Appendix H

Comments Received and Responses

U.S. Forest Service Comments on Draft Submittal

Kentucky Draft Regional Haze State Implementation Plan (RH SIP) - Specific Comments

Figure 14: Ghent Station Unit 1 NO_x Emission Rate Trends (2018-2021)

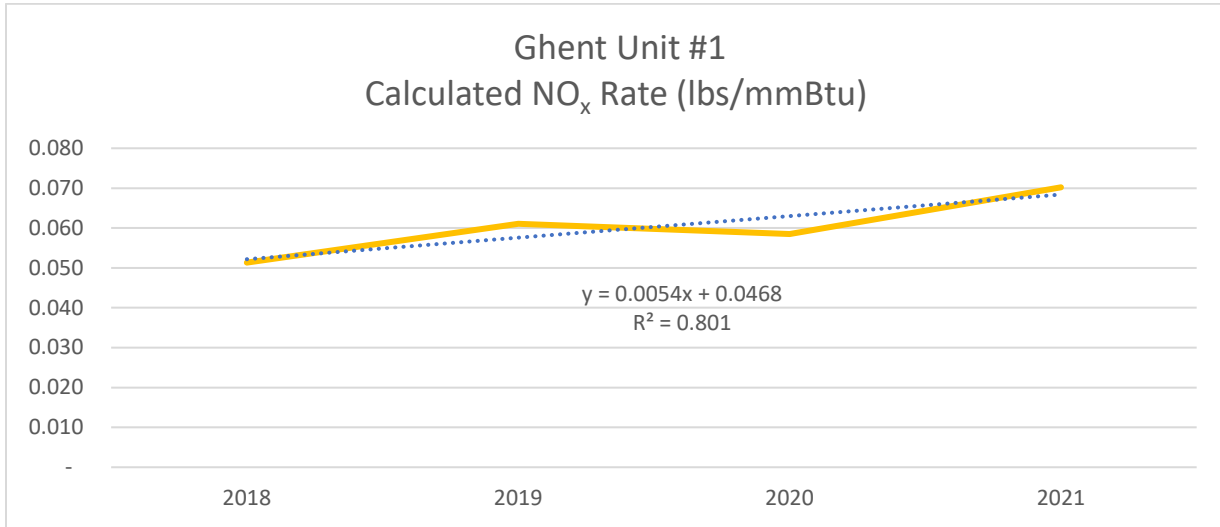
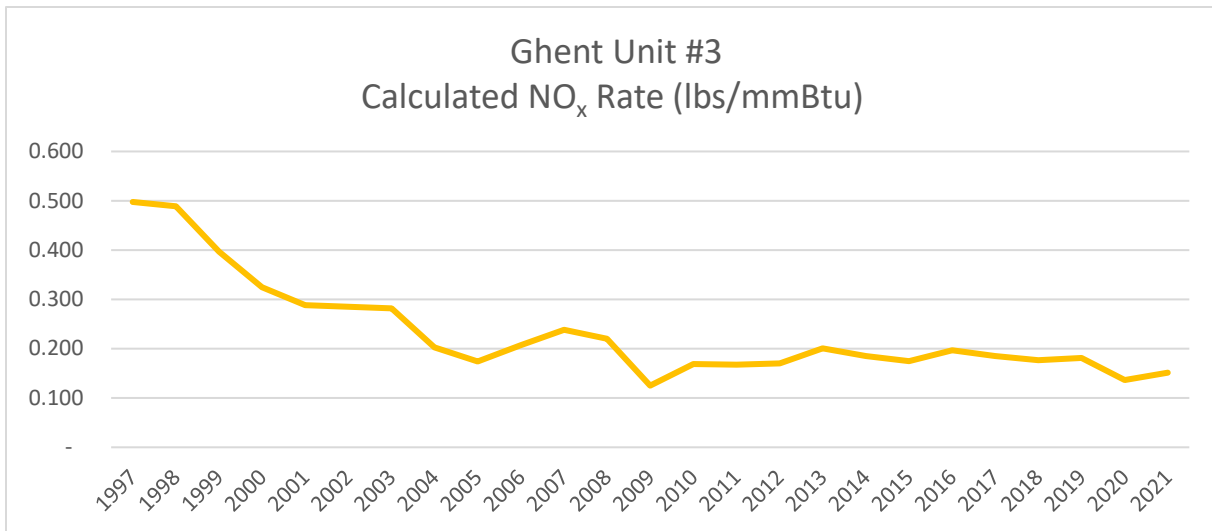
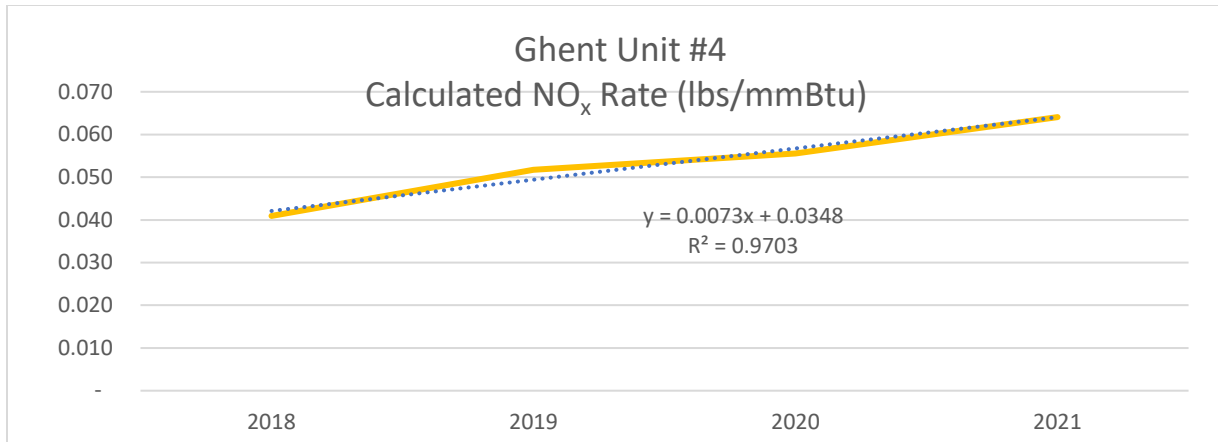
The following figures provide NO_x emission rate trends for SCR systems on Ghent Units 1, 3 and 4.

Based on the unit-specific emission trends, the NPS recommends the following for the SCR systems on units 1, 3 and 4:

Figure 17: Spurlock Station Unit 1 SO₂ Emission Rate Trends (1997-2021)

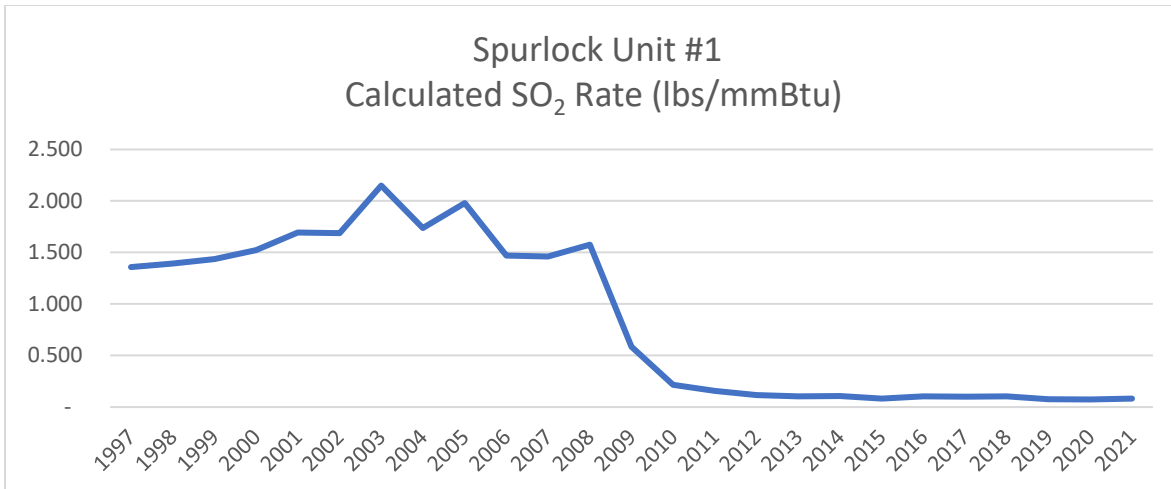
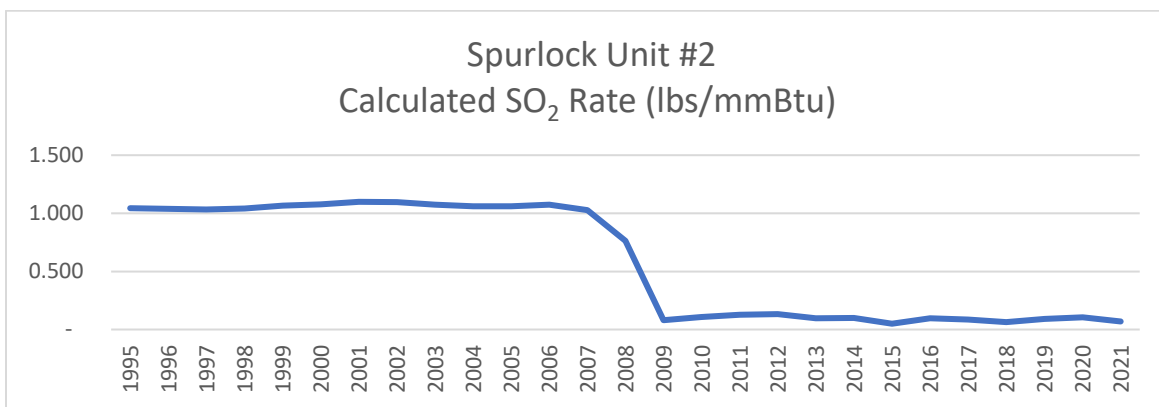
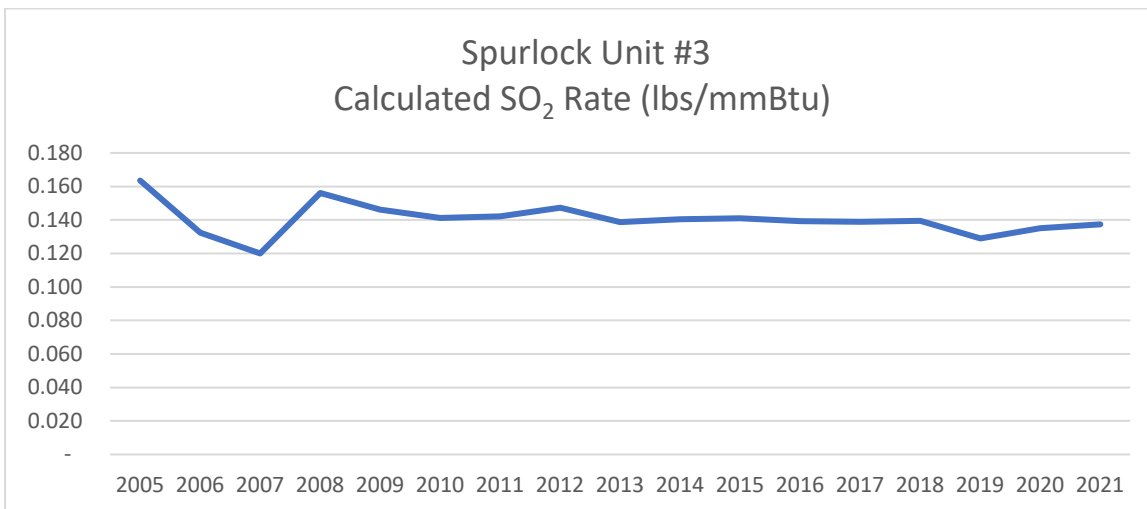
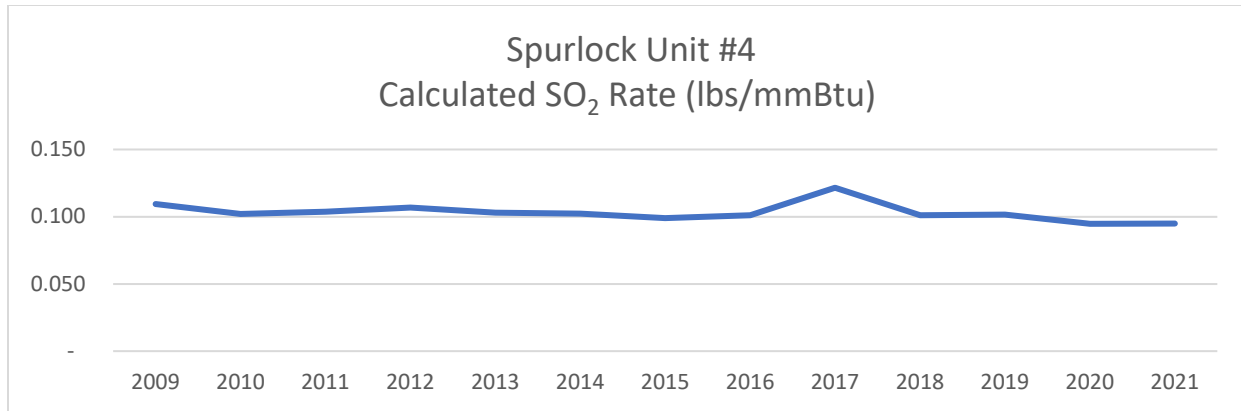
The following figures provide SO₂ emission rate trends for Spurlock Station Units 1-4.

Based on the unit-specific emission trends, the NPS recommends the following for the wet limestone scrubbers:

- Units 1 and 2: The wet limestone scrubbers (with DSI) on units 1 and 2 are achieving greater than 98% control and reducing SO₂ emissions to less than 0.09 lb/mmBtu; these units are effectively controlled.
- Unit 3: The fluidized bed limestone injection with DSI added in 2014 is achieving 97.4% SO₂ control with an associated emission rate of 0.136 lb/mmBtu. Unit 3 SO₂ controls should be evaluated to determine if they can achieve an SO₂ emission rate like those achieved by Unit 4 (or better).
- Unit 4: The fluidized bed limestone injection with DSI added in 2014 is achieving 98.0% SO₂ control with an associated emission rate of 0.102 lb/mmBtu. This unit is effectively controlled.

Figure 21: Spurlock Station Unit 1 NO_x Emission Rate Trends (1997-2021)

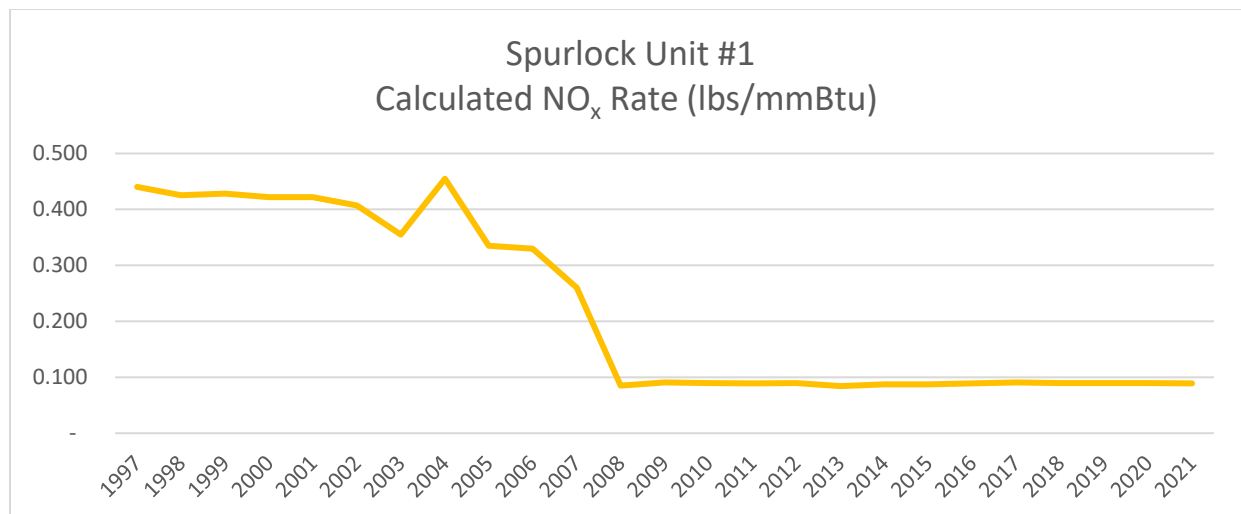
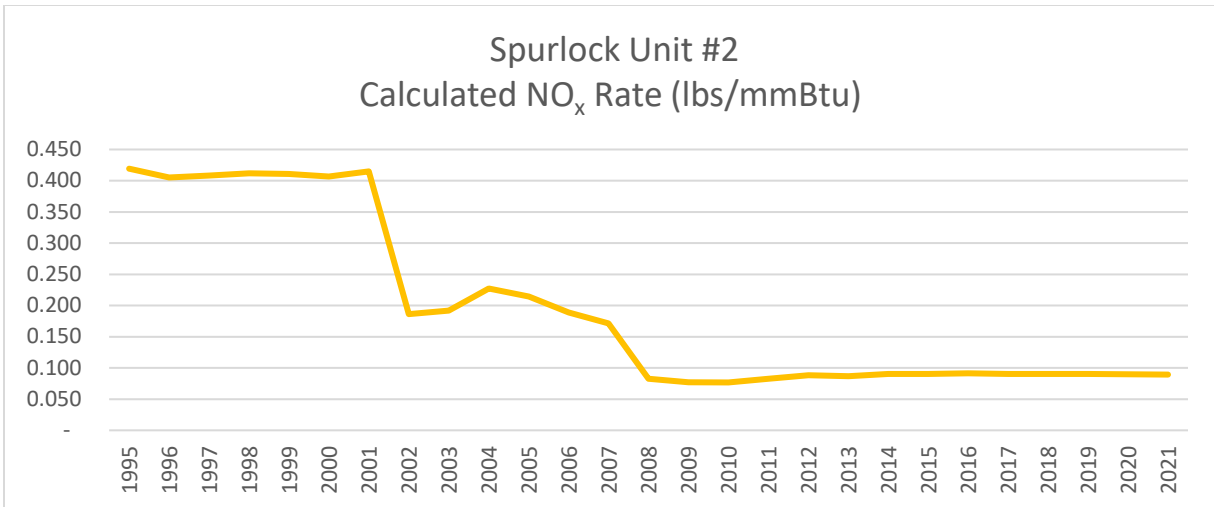
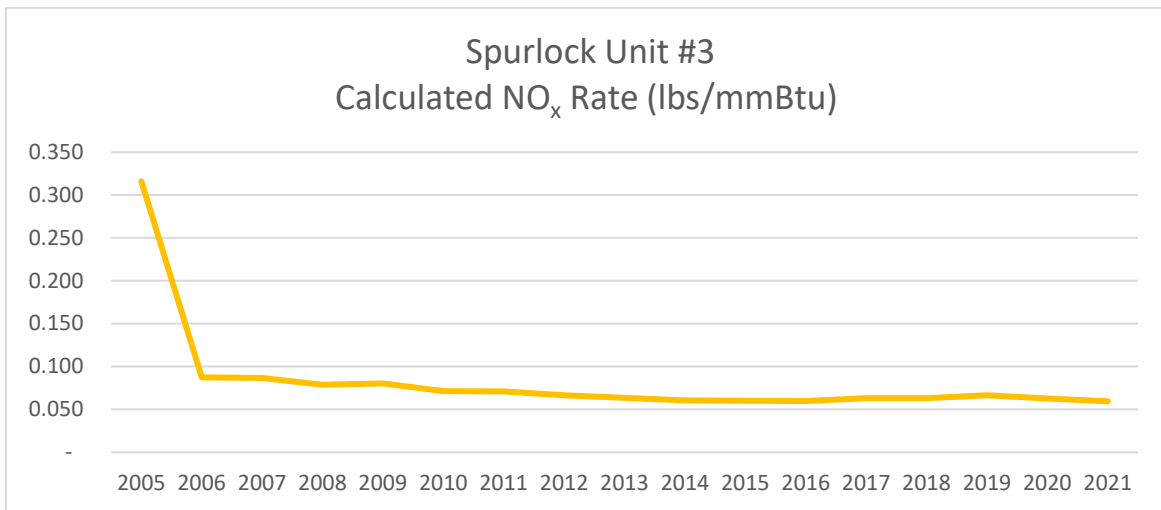
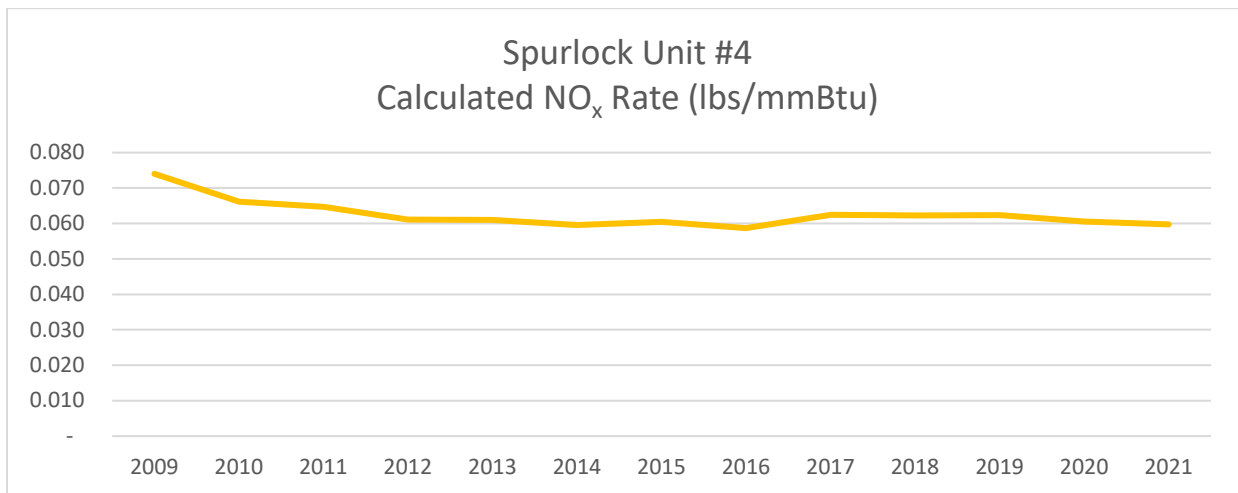
The following figures provide NO_x emission rate trends for SCR systems on Spurlock Units 1-4.

Based on the unit-specific emission trends, the NPS recommends the following for the SCR systems on Spurlock units 1, 3 and 4:

Figure 25: Trimble County Station Unit 1 SO₂ Emission Rate Trends (1995-2021)

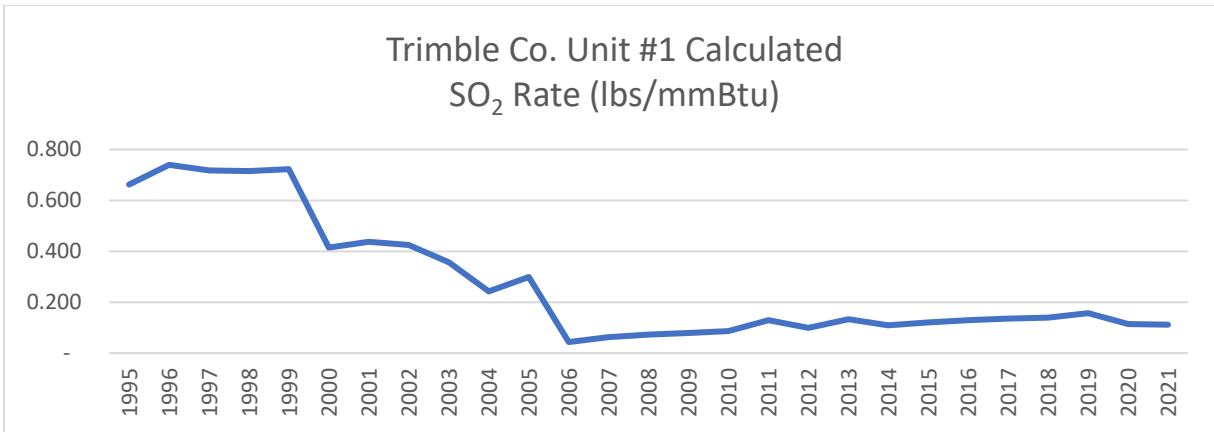
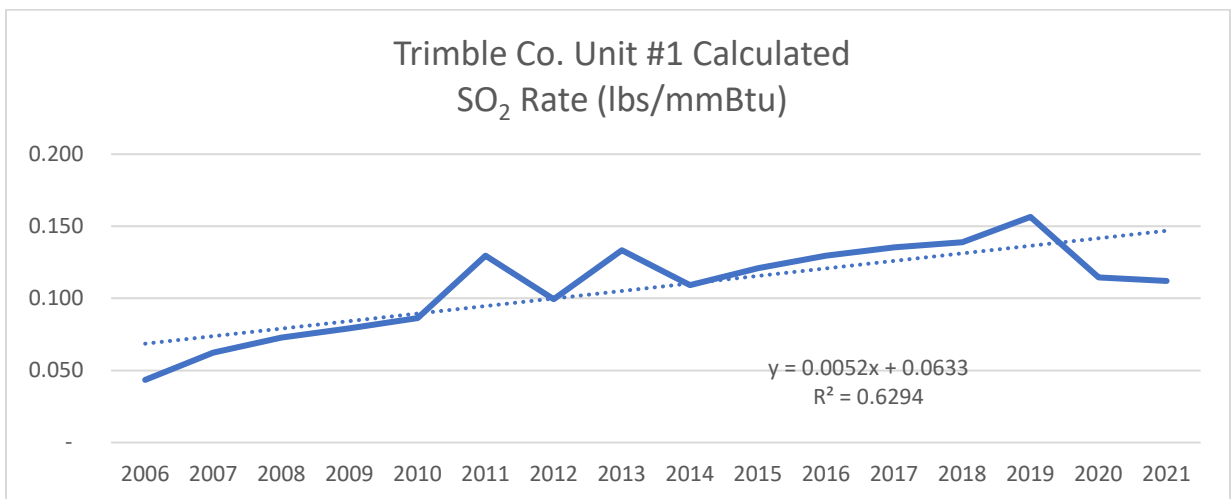
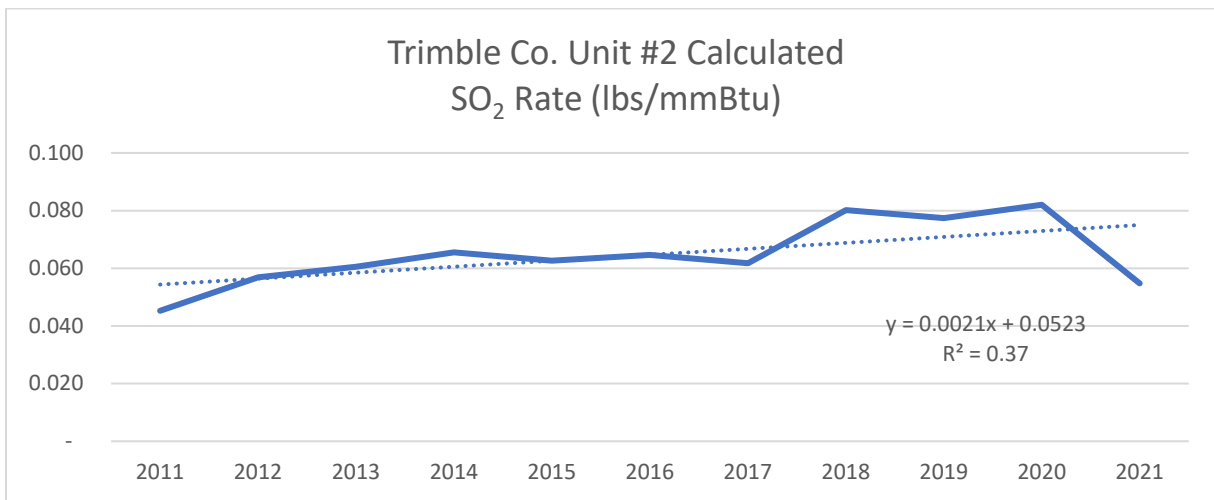
The following figures provide SO₂ emission rates for Trimble County Station Units 1 and 2.

Based on the unit-specific emission trends, the NPS recommends the following for the Trimble County Station wet limestone scrubbers:

Figure 28: Trimble County Generating Station Unit 1 NO_x Emission Rate Trends (1995-2021)

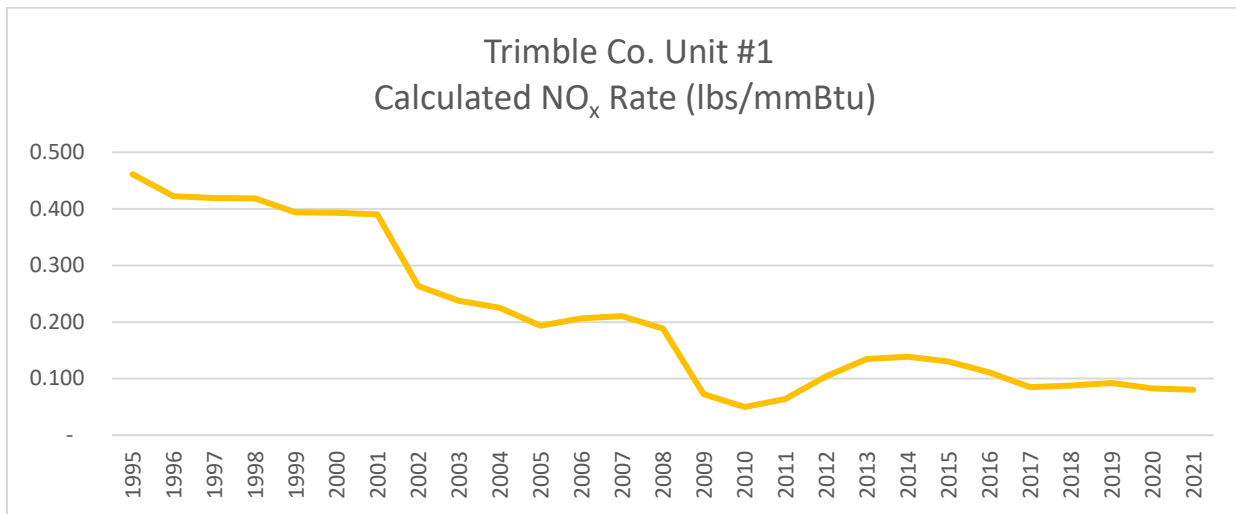
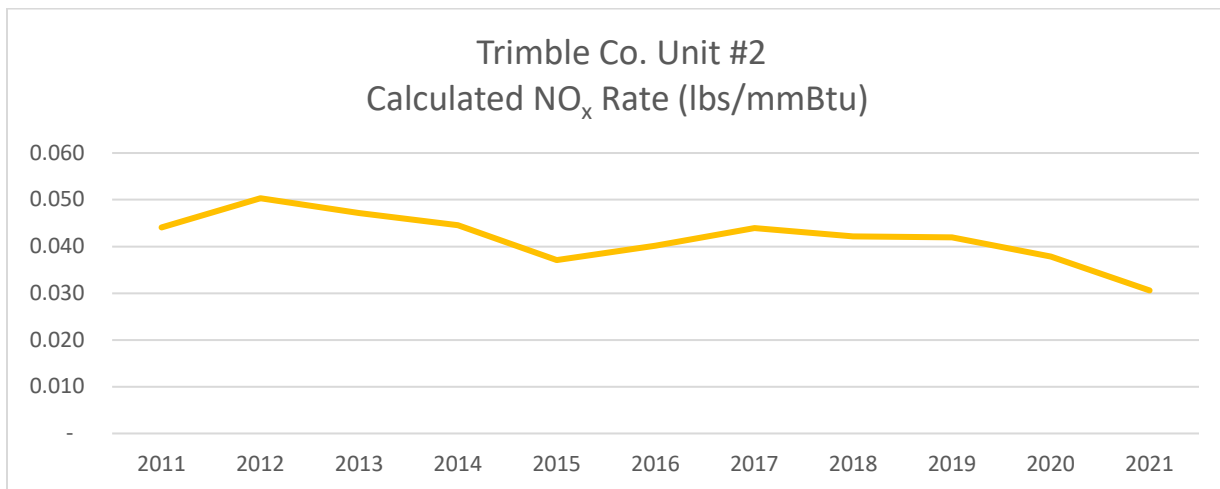
The following figures provide NO_x emission rate trends for SCR systems on Trimble County Station Units 1 and 2.

Based on the unit-specific NO_x emission trends, the NPS recommends the following for the SCR systems on Trimble County Station units 1 and 2:

Figure 30: East Bend Station Unit 2 SO₂ Emission Rate Trends (1995-2021)

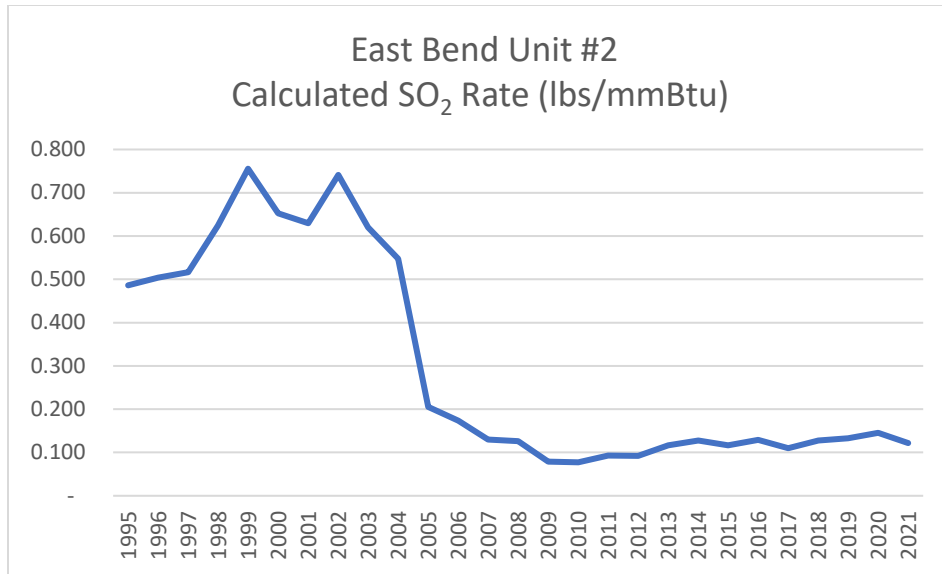
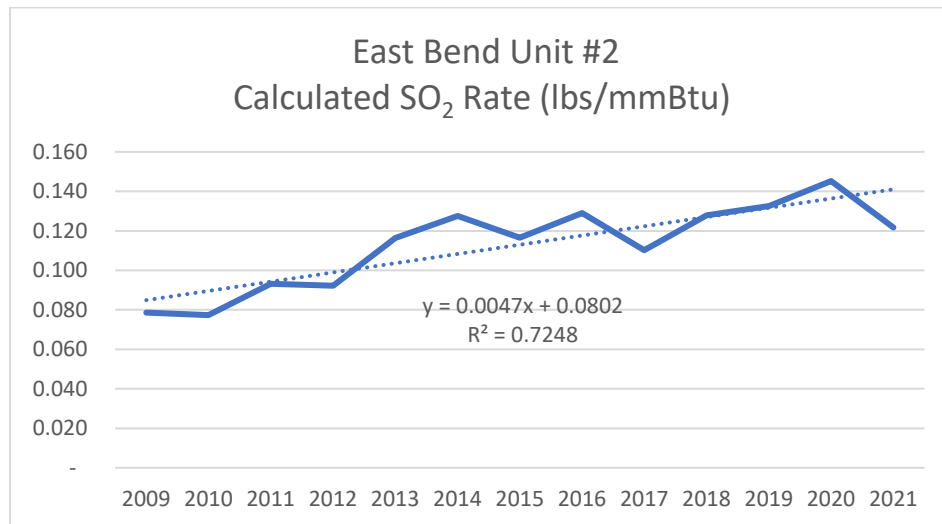
The following figures provide SO₂ emission rate trends for the East Bend Station Unit 2. According to CAMD, Unit 2 has operated with a wet limestone scrubber since 1995. It appears scrubber performance increased around 2005 but performance has been steadily declining since 2010. Based on NPS estimates, the scrubber is currently achieving approximately 97% control.

Similar to the analysis for D.B. Wilson, the NPS evaluated the costs of scrubber replacement with a higher efficiency scrubber. To verify that the assumed emission rates associated with the potential control efficiencies are within the range of rates demonstrated in practice, the NPS compared the anticipated emission rates to values for similar coal-fired units in CAMD. Uncontrolled emissions were calculated using five years of EIA fuels data and AP-42 emission factors for uncontrolled SO₂ emissions from bituminous coal-fired PC dry bottom wall-fired units.³⁴ Based on this information, the NPS estimates that the existing scrubber system is
